UNITED STATES PATENT AND TRADEMARK OFFICE

APPLICATION NO.	FILING DATE	FIRST NAMED INVENTOR	ATTORNEY DOCKET NO.	CONFIRMATION NO.
10/757,017	01/14/2004	Heinrich Kladders	1/1448	3319

Office Action Summary

DETAILED ACTION

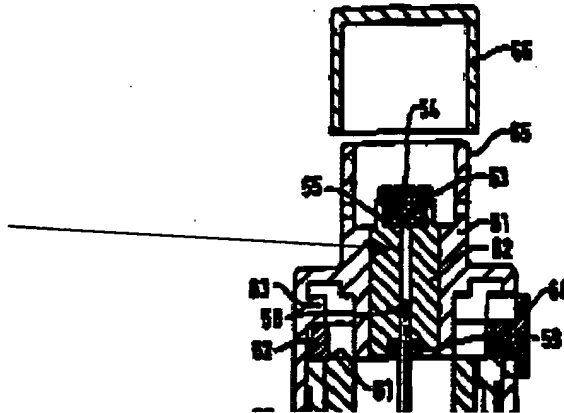
With regard to claim 8, Jaeger discloses the nozzle system according to claim 7 wherein the nozzle holder (54) comprises a bore (7) or hole (7), which is constructed as an inner recess which widens out (33) continuously from the nozzle opening.

With regard to claim 10, Jaeger discloses a side of a recess remote from the nozzle opening

the arrow points to the side of the recess, remote to the nozzle opening (54).

Jaeger does not disclose however that this structure is produced by microtechnology or nanotechnology. However, this is a product-by-process claim where the product is side of the recess, remote to the nozzle opening and the process is producing this said structure by microtechnology or nanotechnology.

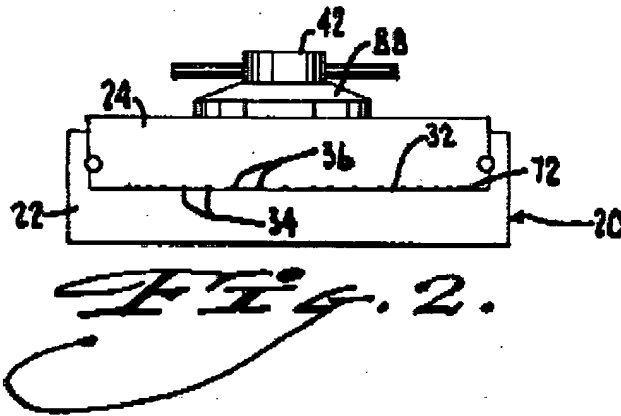
Therefore, it would have been obvious, to one of ordinary skill in the art at the time of the invention, to modify the outer surface of the liquid outlet side of the nozzle of Jaeger so that it includes grooves, or elevations and/or depressions on the surface structure as taught by Waldrum in order to emit uniform droplet sizes from 0.1 to 100 microns in size because doing so would provide an evenness of the application of the spray as taught by Waldrum.

With respect to claim 17, Waldrum teaches wherein the spacings between the elevations and depressions are in the range from 0.1 to 200 microns. "One or both of the nozzle plug and the nozzle body have a plurality of narrow grooves (or elevations and/or depressions on the surface structure). This dimension of 0.001 to 0.015 inch is equivalent to 25 to 400 microns in width and therefore covers the claimed range (Abstract).

With respect to claim 18, the production by microtechnology/nanotechnology is a product-by-process limitation. As shown in Figure 2, the grooves (36) of Waldrum appear to account for at least 20%, more than likely much more, of the corresponding surface.
